**Re: Order of Conditions, DEP File No. 006-1648
Parkway Apartments
1545 – 1555 VFW Parkway, W. Roxbury, MA.**

On behalf of Lincoln Parkway, LLC (the “Proponent”), Howard Stein Hudson and Epsilon Associates, Inc. respectfully submit this Request for an Amendment to the Order of Conditions (OOC) issued on April 17, 2019 for the above-named Project, to delete Special Condition No. 68 from the OOC, and to approve a minor plan change to increase the amount of compensatory flood storage.

**Re: Parkway Apartments Order of Conditions, DEP File No. 006-1648
Engineering Certification/Minor Plan Modification Regarding Base Flood
Elevation and Compensatory Flood Storage**

Exhibit A – Flood Insurance Study Panels

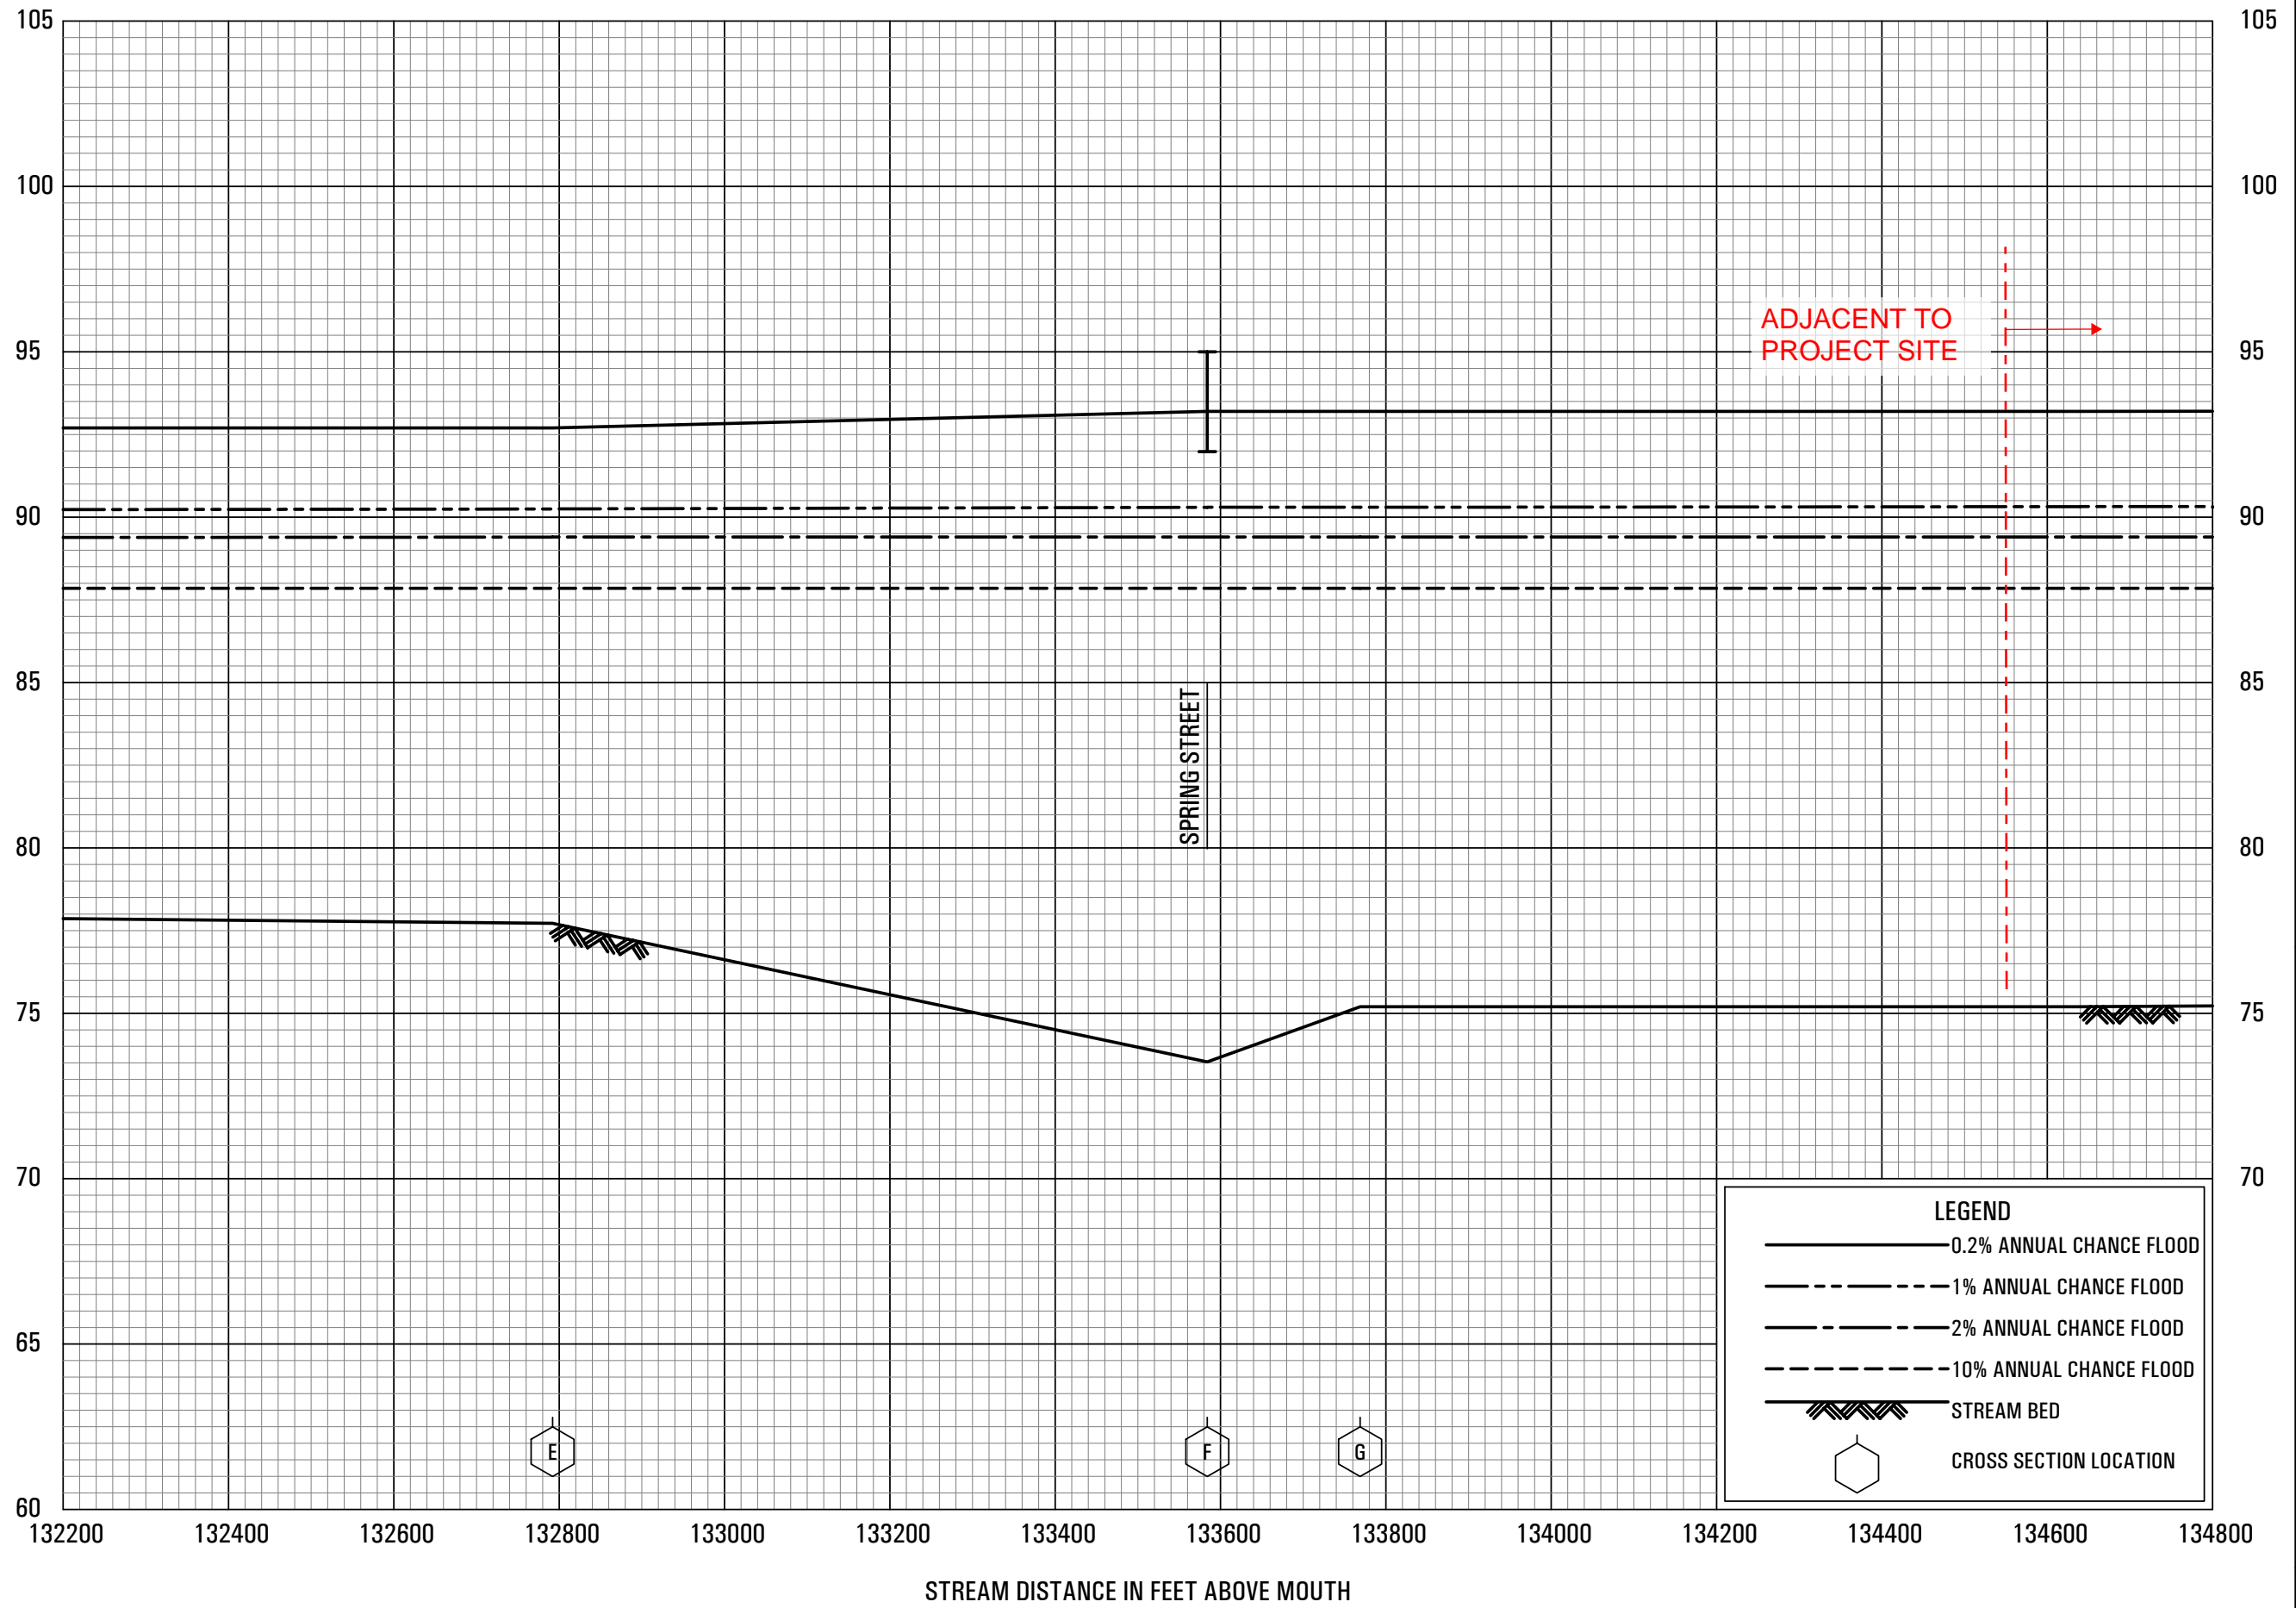
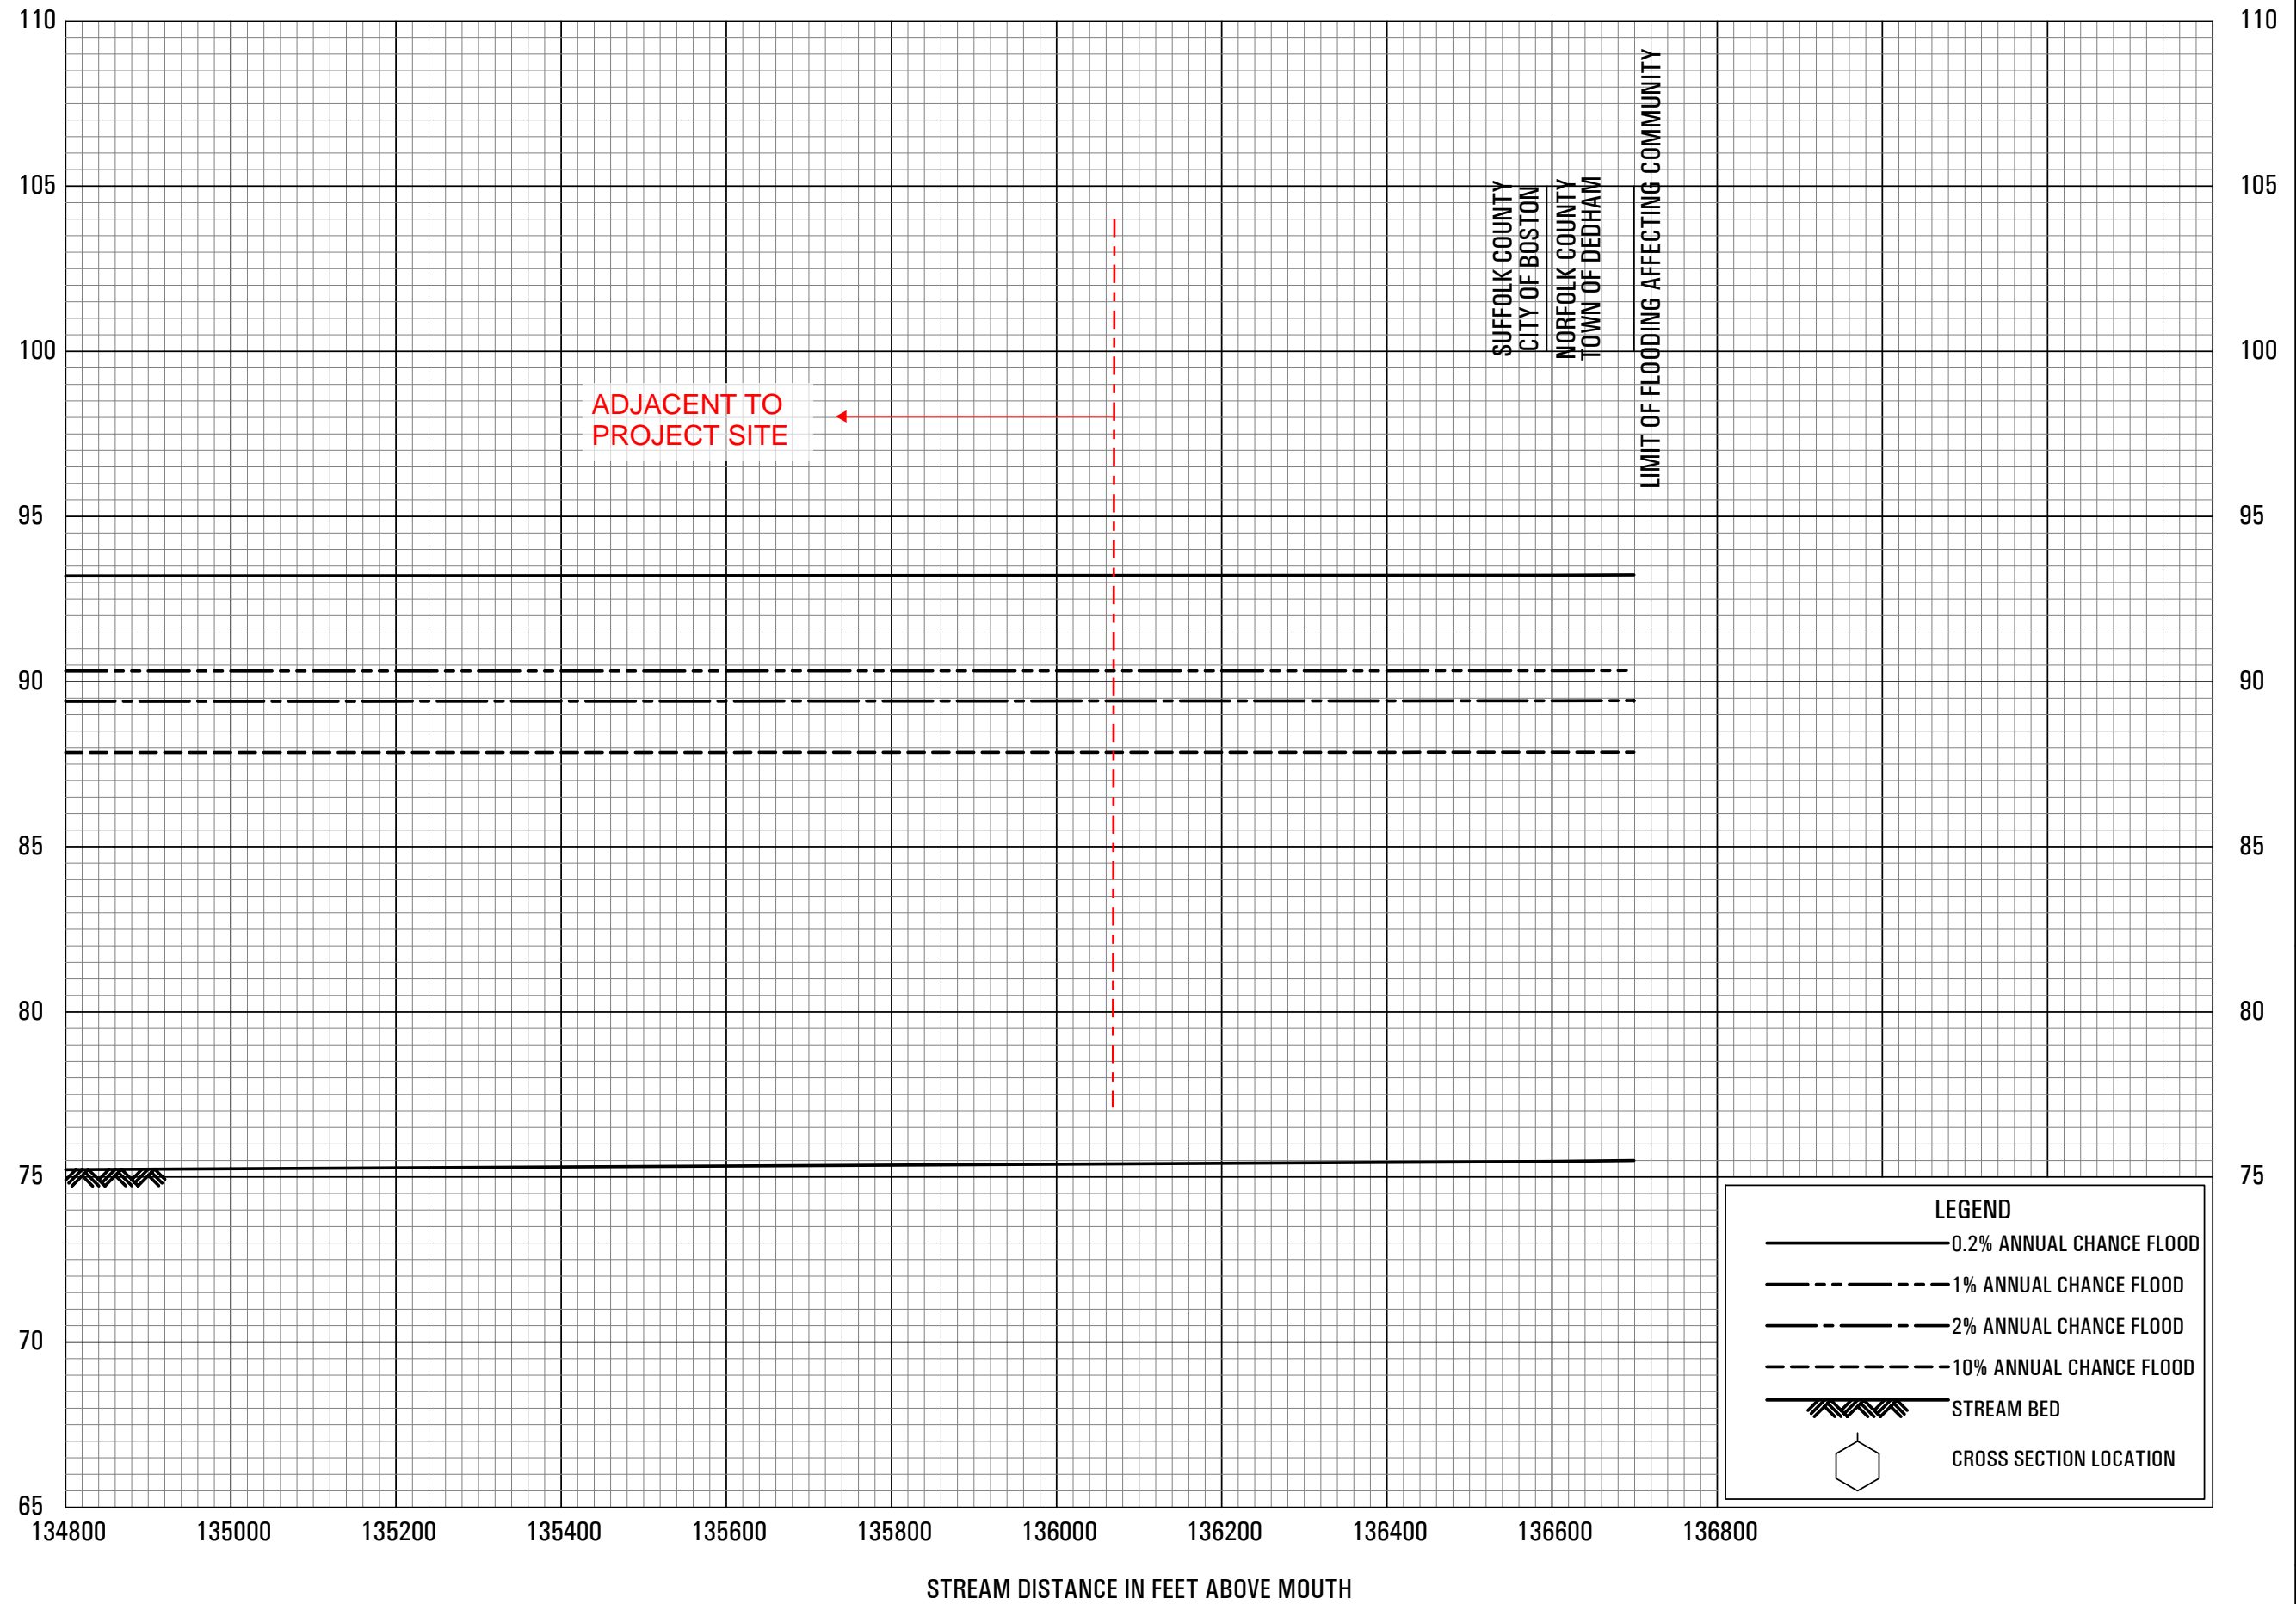
1. Data provided in the Federal Emergency Management Agency ("FEMA") Flood Insurance Study No. 25025CV000B, Suffolk County, MA, Revised March 16, 2016, (the "FEMA Study") Flood Profiles for Charles River, Panels 04P and 05P (copy attached as Exhibit A), evidences that the Base Flood Elevation ("BFE") at the Project Site is **90.4 feet** North American Vertical Datum of 1988 (NAVD 88), which corresponds to elevation 96.9 feet Boston City Base ("BCB").

2. This BFE is slightly greater than the 90 feet NAVD 88 value used in the Project Notice of Intent ("NOI") to calculate compensatory flood storage. (The 90 foot value was obtained from the most recent Flood Insurance Rate Map, Map Number 25025C0068G, dated September 25, 2009. The corrected value 90.4 is the more conservative and precise BFE value provided by the applicable FEMA Study Flood Profiles as shown in Exhibit A.)

**EXHIBIT
 B**

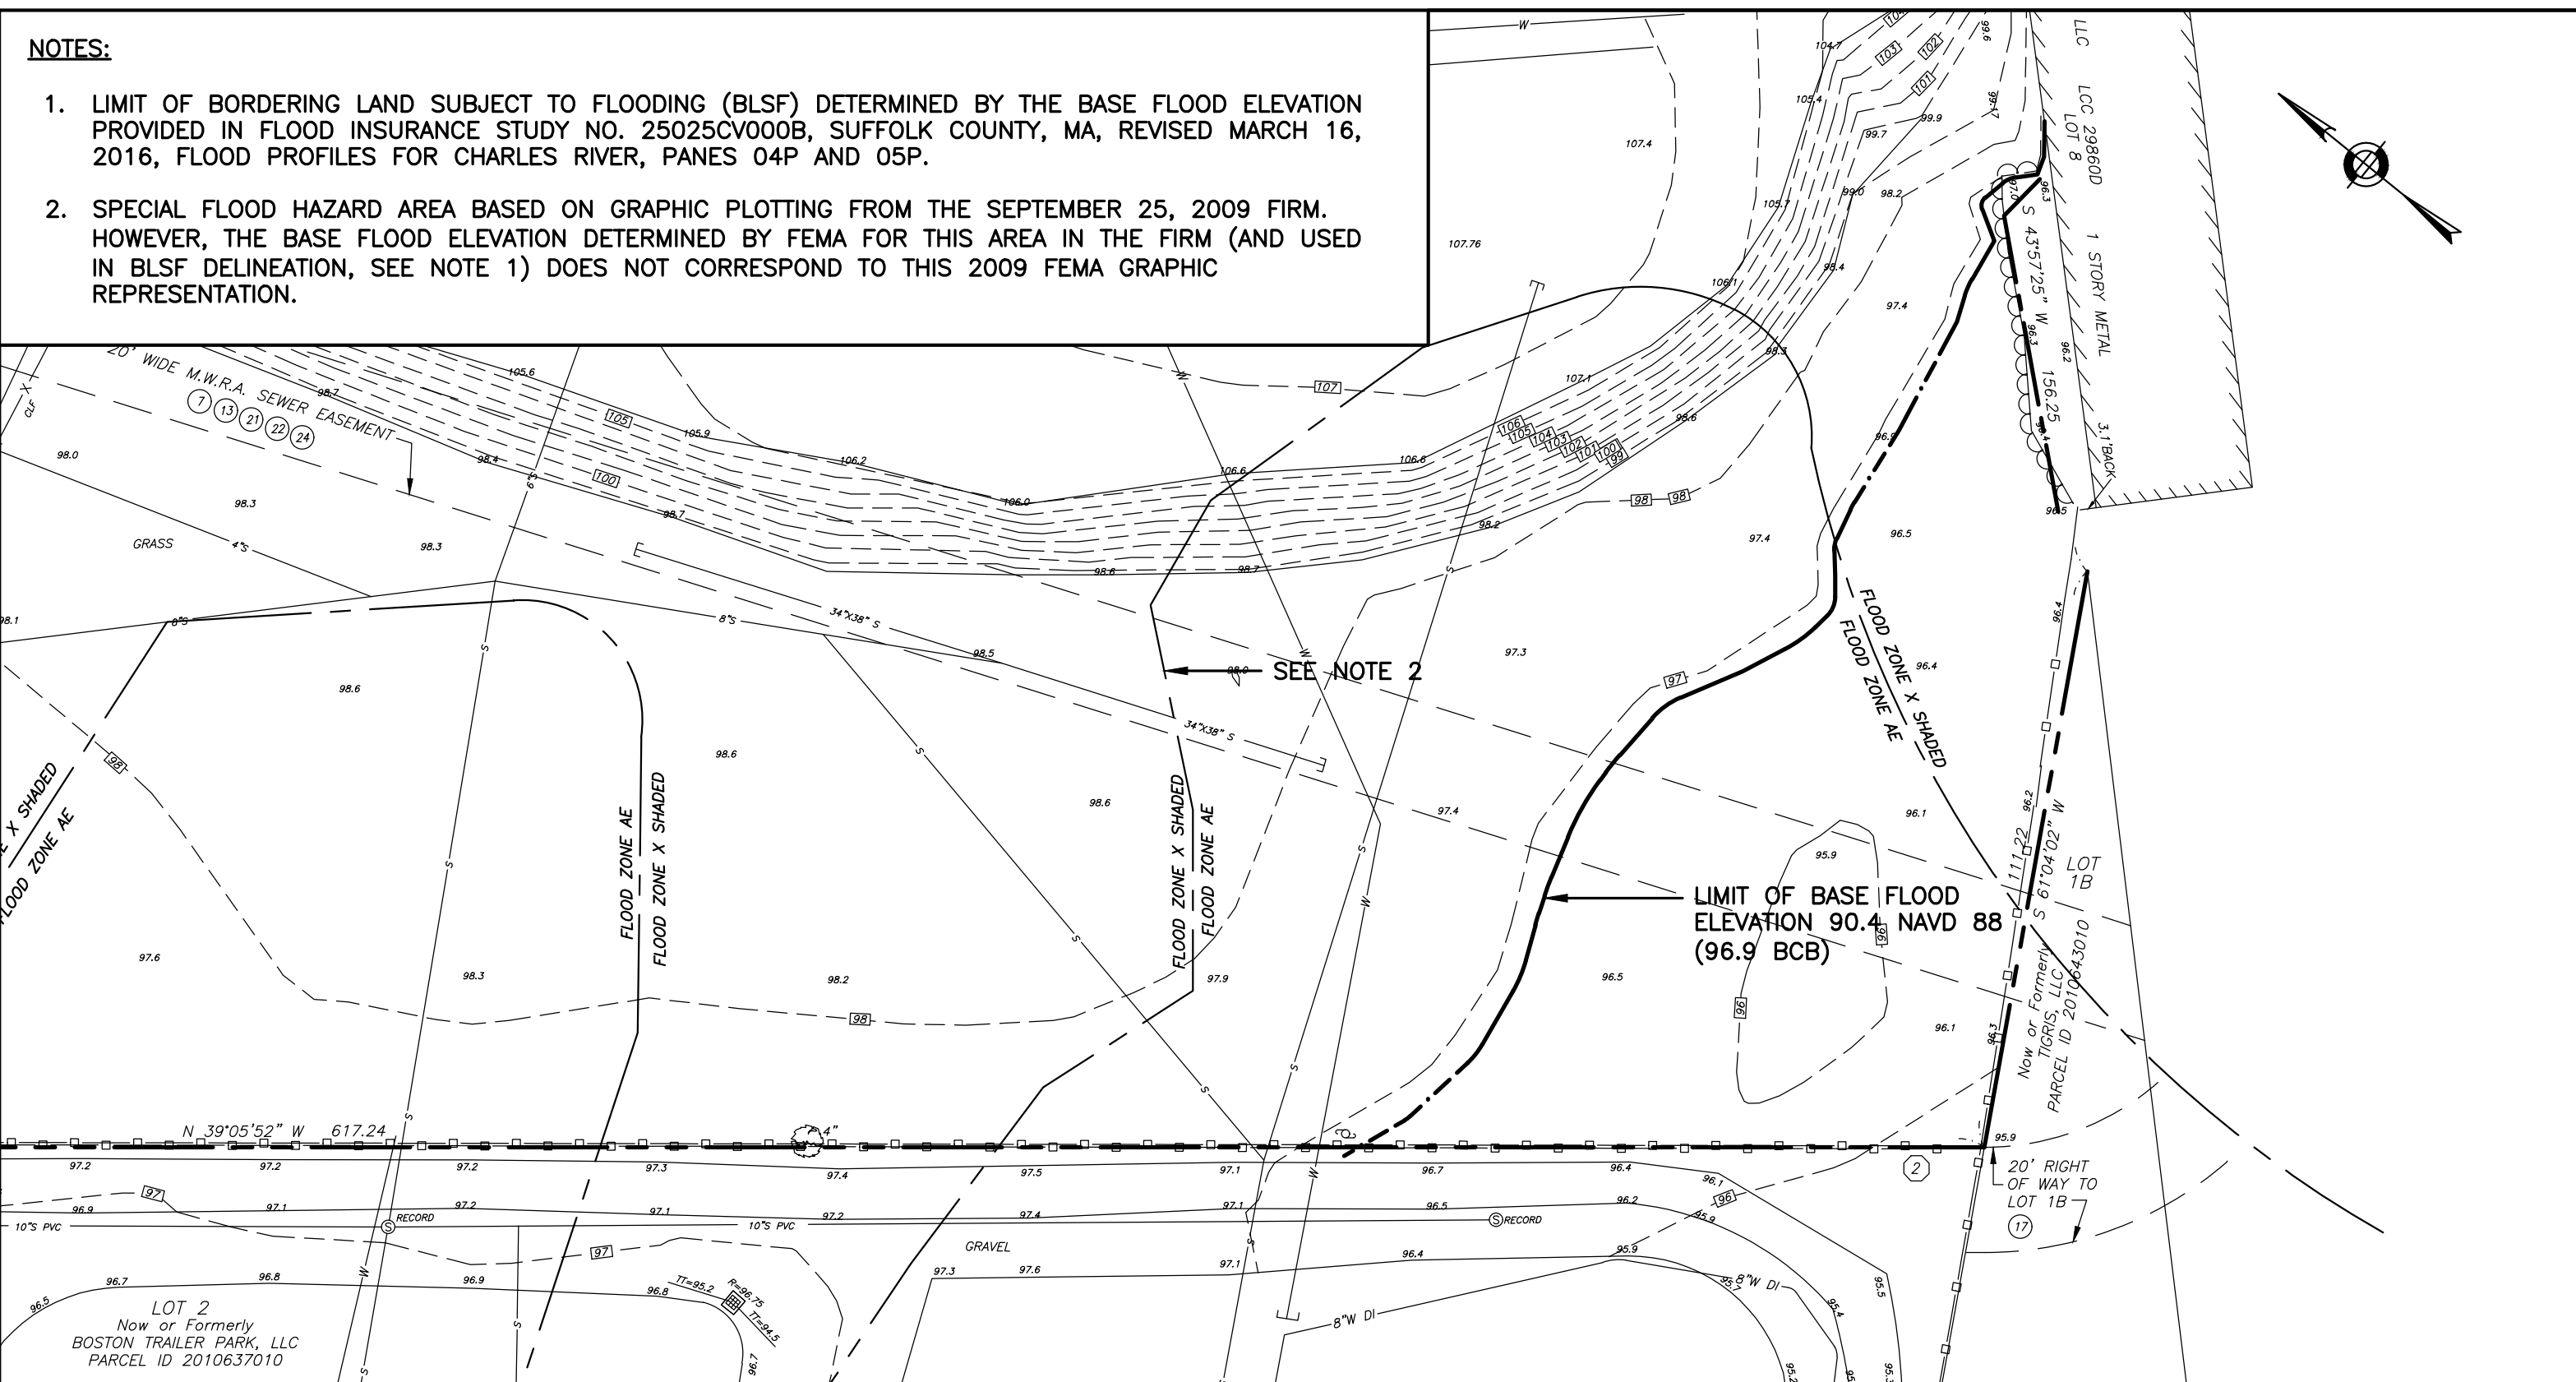
3. Figure 1, attached to this Certificate as Exhibit B, is a true and correct depiction, based on site-specific surveyed elevations, of the location of the BFE 90.4 feet NAVD 88 on the Project Site.
